RE: Telecommunications Facility RF Site Review  
351 Walker Ave, Ashland, OR 97520  
GPS Coordinates: 42.188528/ -122.690097  
Map Tax Lot: 391E10CD100

This supplementary report discusses Applicant's responses to the radio-frequency (RF) aspects of the proposed SmartLink / New Cingular Wireless (AT&T) (Applicant) project in the City of Ashland, OR, as presented in our initial report of August 19, 2021 (the "Preliminary Report"). At that time we presented recommendations for Applicant to supplement the record with a corrected capacity plot, enhanced justification of the necessary antenna height, and clarification of human exposure calculations. Additional subsequent reports, if needed, will address any remaining questions or issues that arise during public hearings at the request of the city. The Preliminary Report contained a summary of our professional qualifications to render opinions regarding the application and background information related to other technical matters.

Figure 2: AT&T Proposed RF Target Area Coverage

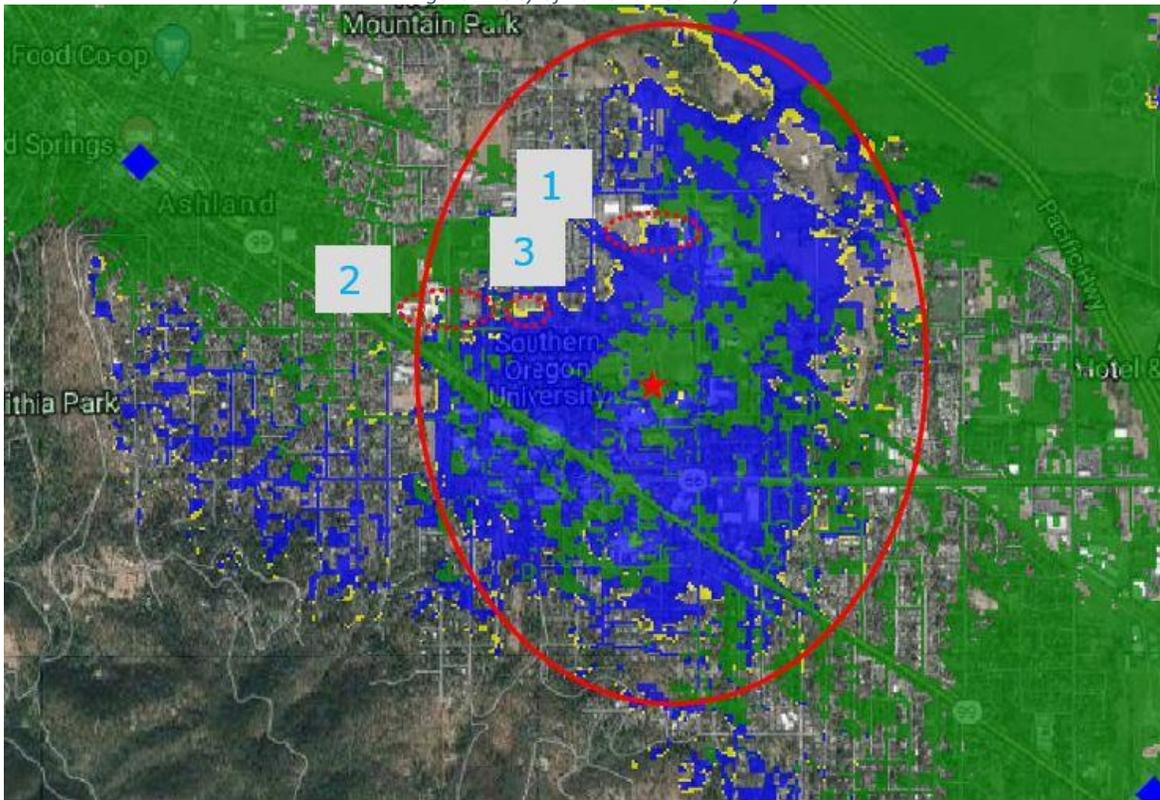
3. The proposed RF site will provide capacity relief to adjacent neighbor base station sites by providing a strong local signal to which nearby wireless devices can connect rather than drawing capacity from the limited 700 MHz spectrum of those neighbor sites. One anticipates continuing growth of wireless devices that will place additional demands on the proposed and neighbor sites. Those increasing demands imply the possibility that Applicant may decide to address those areas as part of their overall wireless network. We recommended the city understand the potential need to serve Applicant’s increasing service demands and how approval of the proposed site will influence the placement and height of future sites within its jurisdiction. Applicant has declined to provide such information under the claim that it is “proprietary.” Unfortunately, this defeats the opportunity for the City of Ashland to prepare and develop strategies to assist Applicant for future deployments in a more cooperative approach. Lacking that opportunity, this report contains the following page of two figures, to approximately the same scale, that allow comparison of the relevant municipal boundaries with the plot of proposed RF coverage by Applicant from the permit application materials to allow the city to assess areas where additional base stations may be required. Areas in gray are those location where RF coverage will be below operating threshold and, therefore, are targets for possible base station deployment. Capacity exhaustion of other existing sites may prompt Applicant to deploy sites to relieve that demand, as is the case with the present proposed site.
